Fig 1A Prior Art

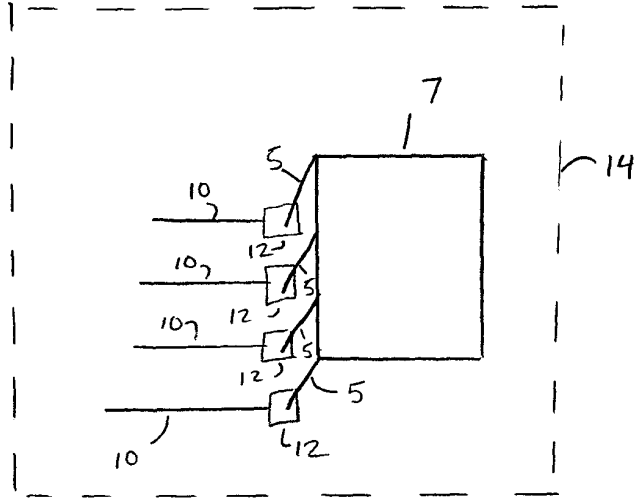
described on page 1, lines 8-11. The pads are connected to traces 10 at 90° angles as is described on lines 13-19.

Fig 1B

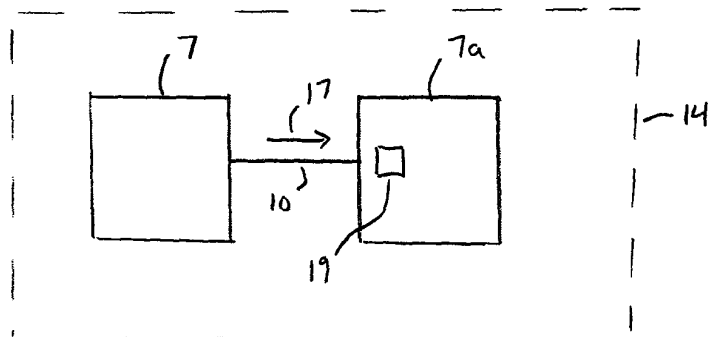
Figure 1B has been added. It shows a block diagram of two components, 7 and 7a, connected on a printed circuit board 14. The components are connected via a trace 10 as is described on page 1, lines 13-15. Digital signals 17 travel from component 7 to component 7a on printed circuit board 14 as is described on page 2, lines 2-4. The destination component 7a has an input receiver 19 which is triggered by the digital signal 17 as is described on page 2, line 4.

Fig 1C

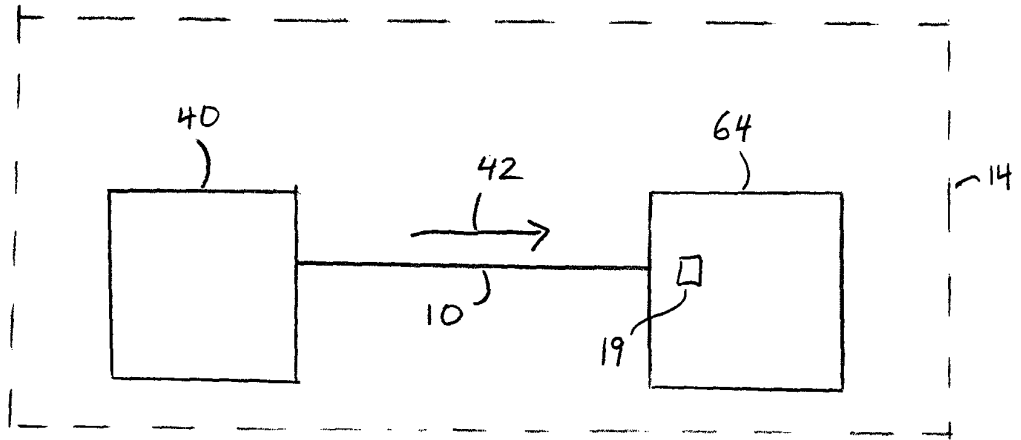
Figure 1C has been added. It shows a block diagram of a memory controller and memory as an example of two components connected on a printed circuit board. On page 2, lines 5-7, the memory controller and the memory are described as an example of the description on page 2, lines 1-5. Therefore, the diagram of Figure 1C is almost identical to that of Figure 1B, the diagram depicting the description of page 2, lines 1-5. Figure 1C has component 7 replaced by memory controller 40, digital signal 17 replaced by control signal 42, and component 7a replaced by memory 64. This is in accordance with the specific example described on page 2, lines 5-7.

Figure 7

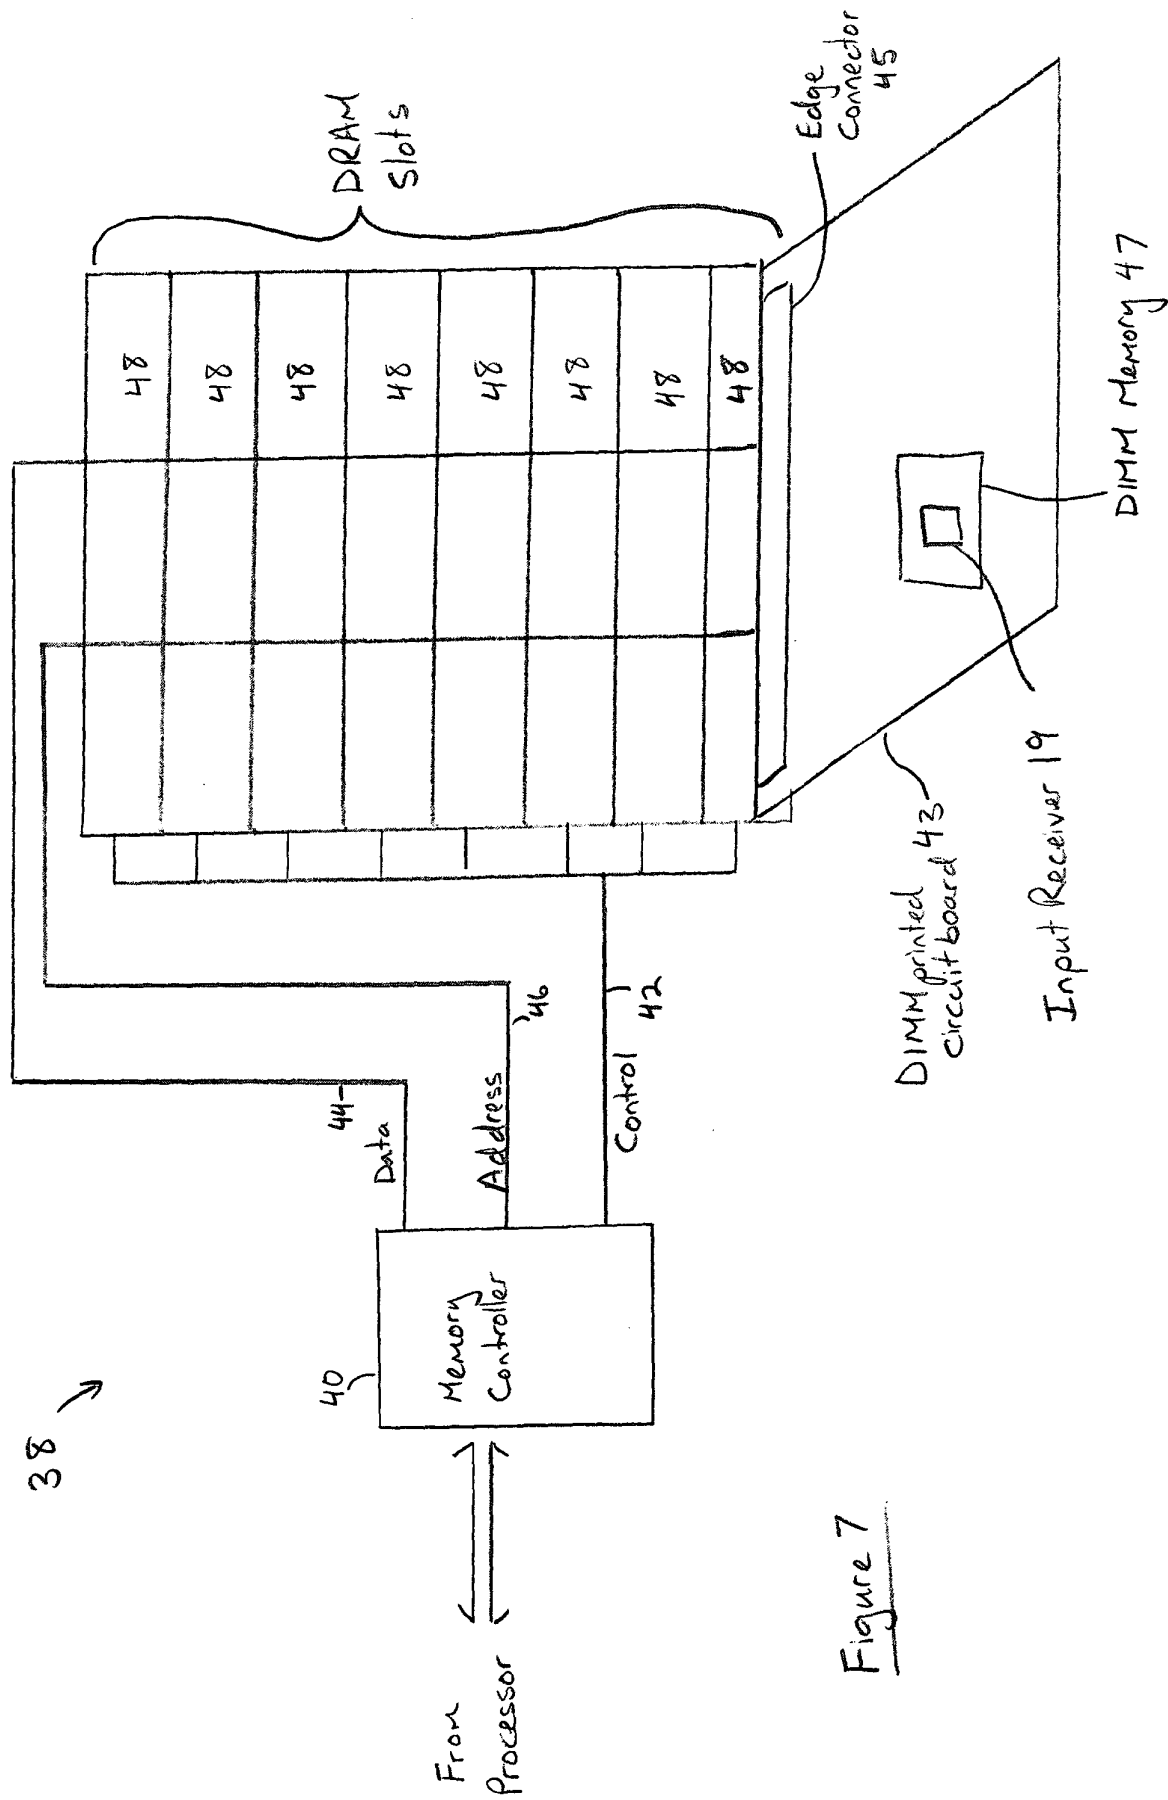
In Figure 7, a number of elements have been added. One such element is DIMM printed circuit board 43. The DIMM printed circuit board 43 is described on page 10, lines 14-15 as a separate printed circuit board where the DRAM DIMMs reside. DIMM printed circuit board 43 connects to slot 48 via an edge connector 45. The edge connector 45 was shown but previously unlabelled in Fig. 8. The edge connector is now labelled in Fig. 8 and is shown in Fig. 7. The

description on page 10, lines 13-14 shows how the DIMM is connected to DIMM slot 48. This has now been illustrated in Fig. 7 and described on page 10 after line 15. Another new element in Fig. 7 is DIMM memory 47 which resides on the DIMM printed circuit board 43. This is described on page 10, lines 14-15 and also lines 17-20 stating that the DIMM printed circuit board 43 is a separate printed circuit board than that containing the memory controller and that the DIMM memory 47 is contained on the DIMM printed circuit board 43. Combining Fig. 1C with the memory as described on page 10, lines 17-20 gives memory, in this case DIMM memory 47, with an input receiver 19, connected to memory controller 40 which sends control signals 42 to DIMM memory 47 via a trace. This has been illustrated in Fig. 7 in accordance with the description on pages 2 (as per Fig. 1C) and 10. As such, no new matter has been added with the amendment to Fig. 7.
